TN-FSV SAFETY ANALYSIS REPORT INFORMATION

TN-FSV SAFETY ANALYSIS REPORT

REVISION 3

TN-FSV SAFETY ANALYSIS REPORT ADDENDUM

Figure 2.11.2-1
Oak Ridge Container, Container Bottom Plate Finite Element Model,
with Boundary Conditions

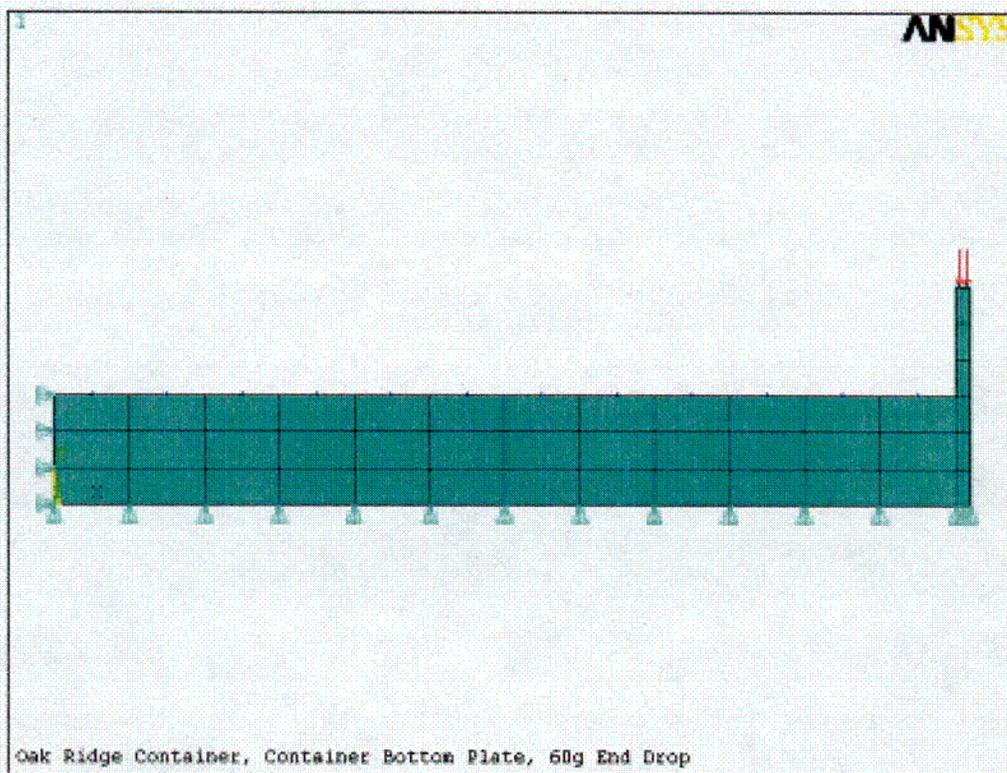
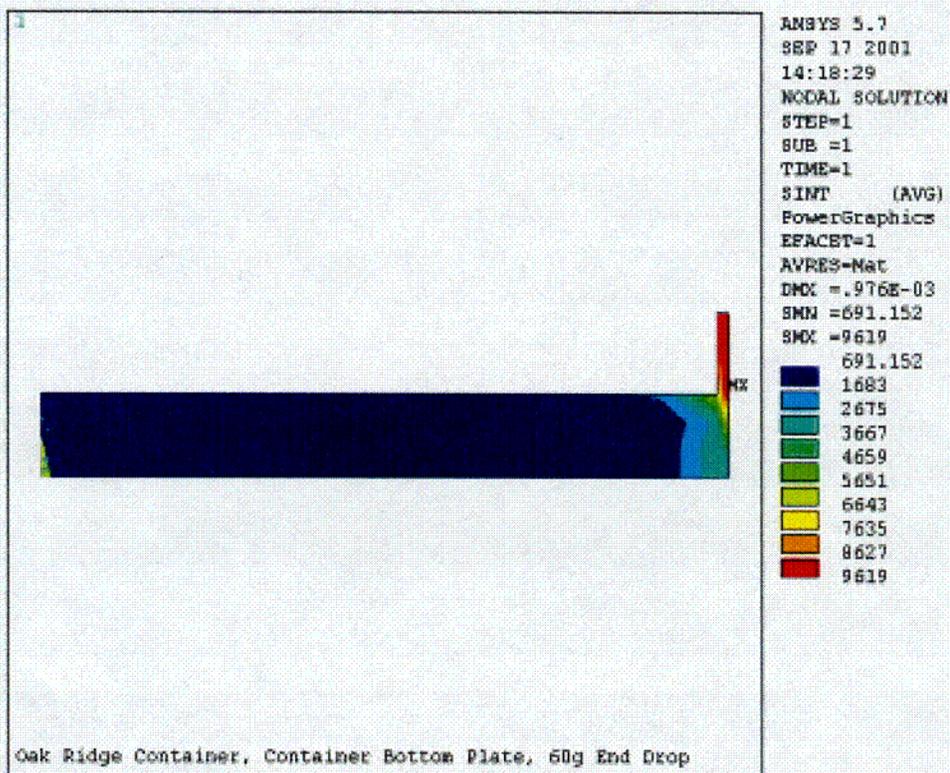
2.11.2-i	Added figures for ORC bottom analysis
2.11.2-9 thru 2.11.2-10	Added ORC bottom drop analysis.
2.11.2-12 & 2.11.2-13	Added figures for ORC bottom analysis

Figure 2.11.2-2 shows the stress intensity distribution computed by ANSYS. The maximum stress intensity in the container bottom plate is 9,619 psi., which is much less than the accident condition membrane stress allowable of 47,950 psi. This accident condition stress intensity is also less than the normal condition membrane allowable stress of 20,000 psi.
